Item Name: Fwd Crosstube - High 206L / L1 / L3 / L4

D206-667-143	Rev C (DEO)
--------------	-------------

DRAWING NO. D206-667-143	TITLE CROSSTUBE ASS'Y (206L HIGH FWD)	REV. C	DART AEROSPACE LTD ENGINEERING ORDER		D.E.O. NO. D206-667-143-C-1	SHEET NO. SHEET 1 OF 1	SCALE NTS
DRAWN <i>q</i>	CHECKED <i>ASS</i>	MFG. APPR. <i>ASS</i>	APPROVED <i>WD</i>	DE APPR. <i>WD</i>			
DATE 11.07.15	DATE 11.07.20	DATE 11.07.21	DATE 11/07/21	DATE 11-07-21

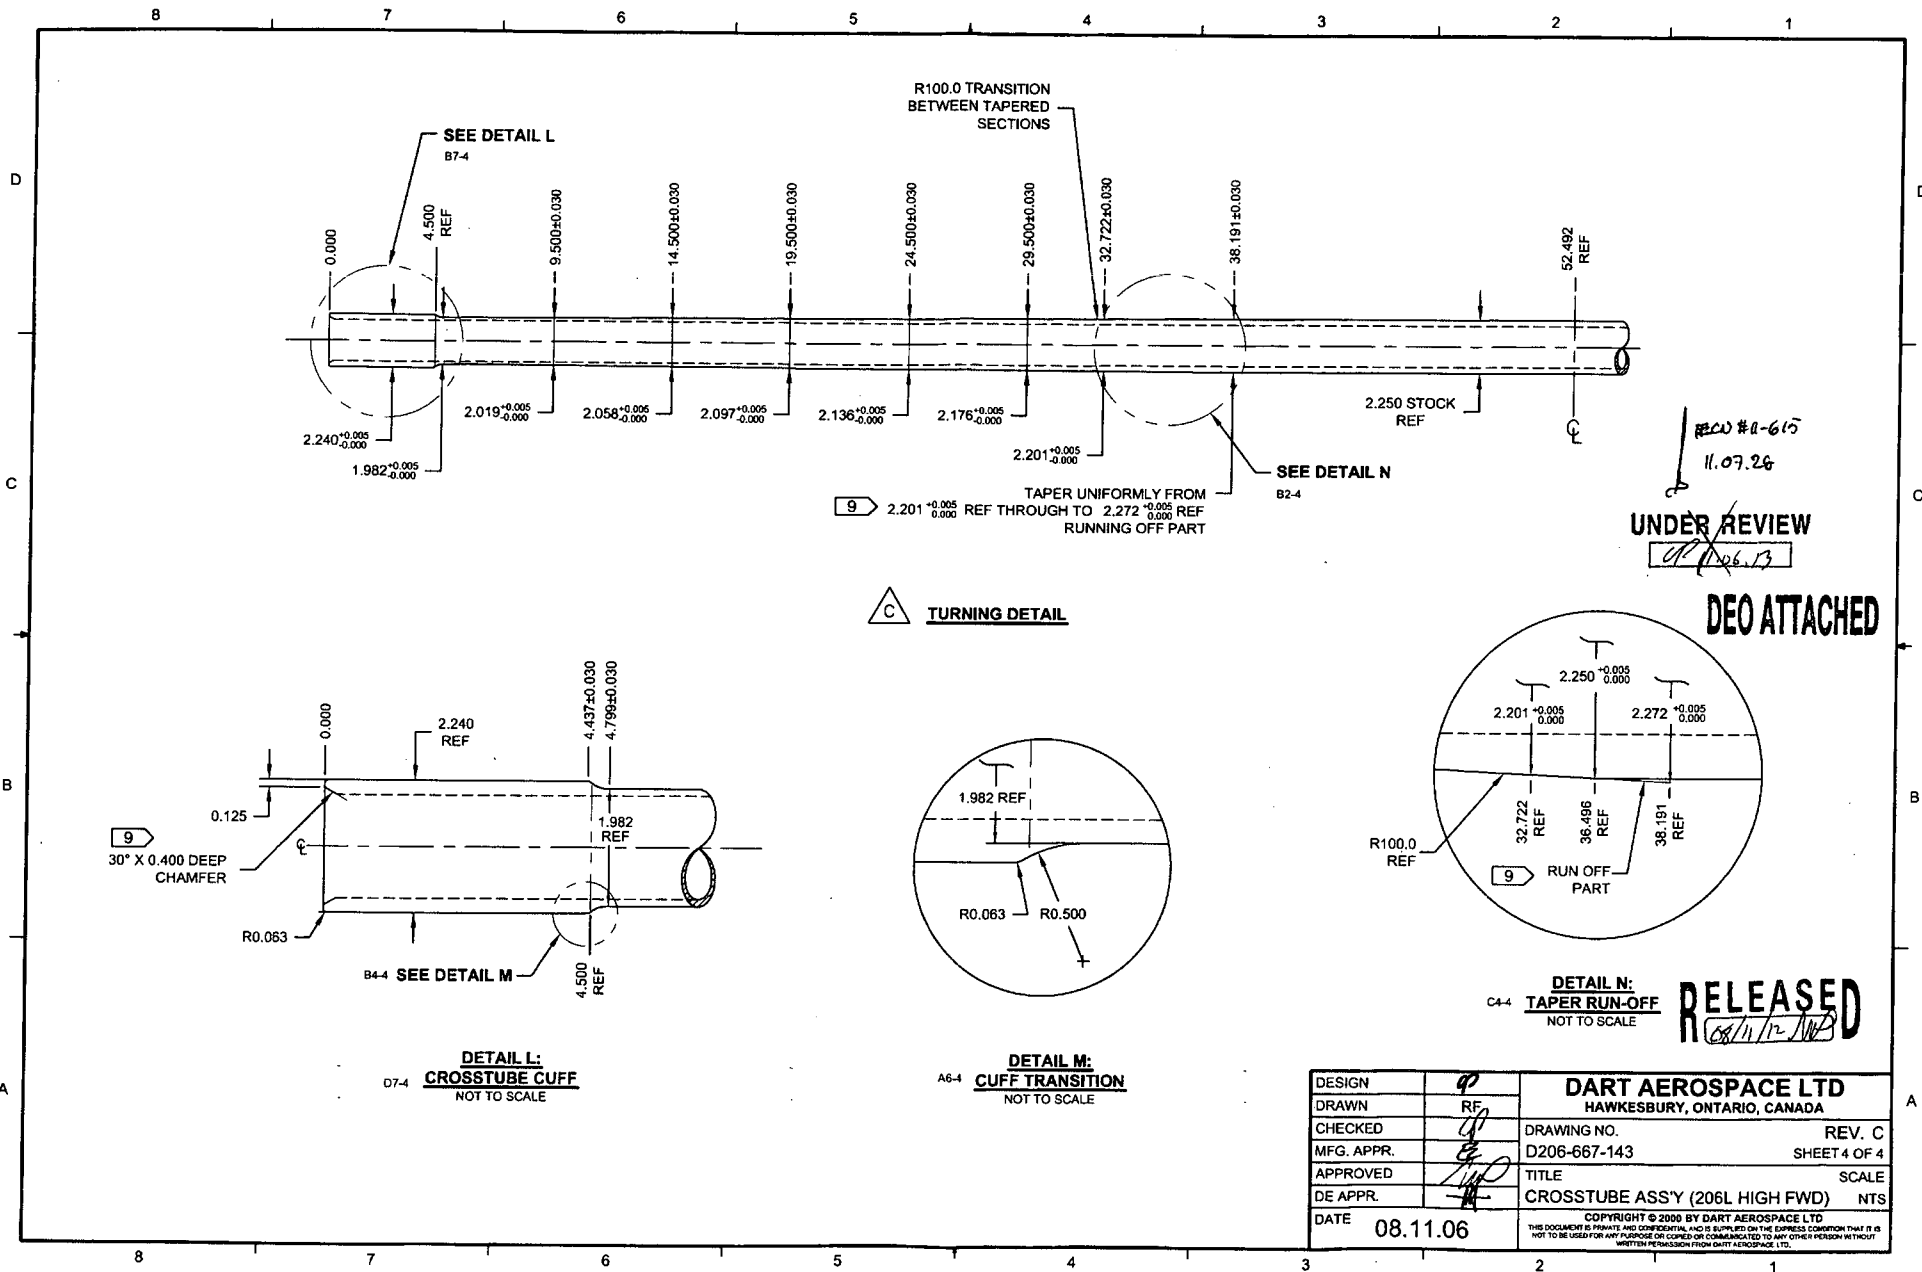
PURPOSE:

REPLACE MAGNOBOND WITH PROSEAL.

NOTE 12 & 15, SHEET 1 IS AMENDED AS FOLLOWS:

- 12) TO INSTALL D2891-1 SUPPORT: ABRASE MATING SURFACE OF SUPPORT AND CROSSTUBE WITH 180-GRIT SANDPAPER AND REMOVE RESIDUE WITH MEK (OR EQUIVALENT). APPLY A 0.04" TO 0.07" THICK LAYER OF PROSEAL 890 CLASS B-2 (OR AMS-S-8802 CLASS B-2) SEALANT TO MATING SURFACE OF SUPPORT.
- 15) TORQUE CLAMPS 80 TO 100 IN-LB. ENSURE AT LEAST 1.5 THREADS SHOWING IN SAFETY AND THAT NUT HAS NOT BOTTOMED-OUT AFTER TORQUING. **PRIOR TO PACKAGING, RE-CHECK TORQUE ON CLAMPS AFTER PROSEAL 890 SEALANT HAS CURED FOR 72 HOURS.**

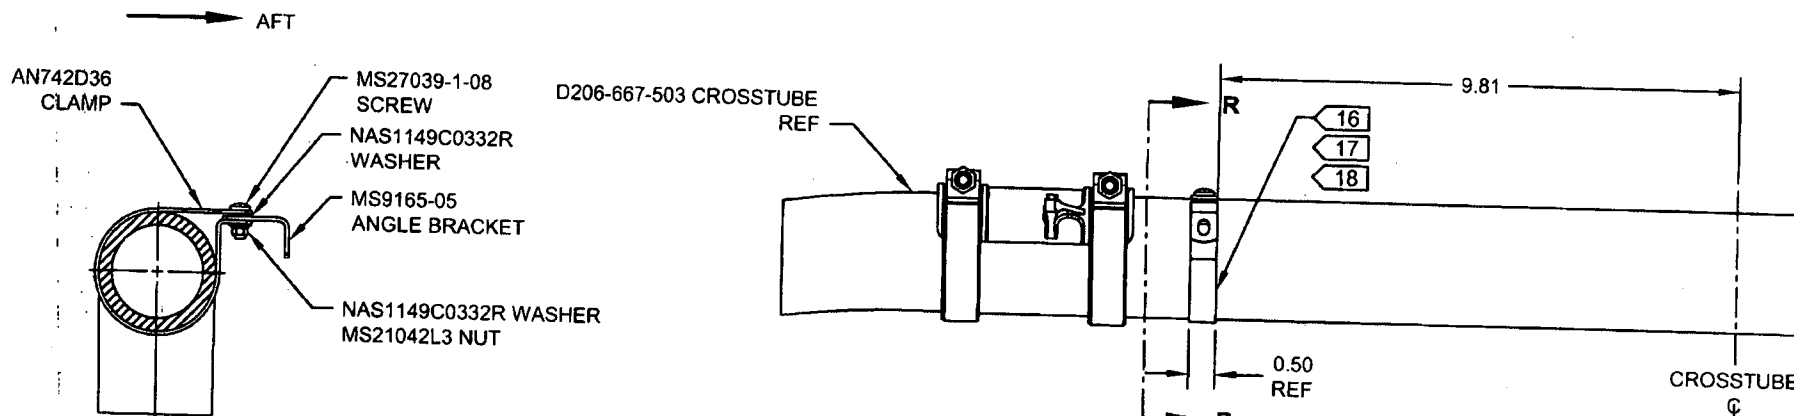
ADD ELECTRICAL GROUNDING STRAP

PARTS LIST:

ITEM	QTY	PART NUMBER	DESCRIPTION
1	X	D206-667-143	CROSSTUBE ASSEMBLY (206L HIGH FWD)
10	2	AN742D36	CLAMP
11	2	MS9165-05	ANGLE BRACKET
12	2	MS21042L3	NUT (OR MS21042-3)
13	2	MS27039-1-08	SCREW
14	4	NAS1149C0332R	WASHER (OR AN960C10L)
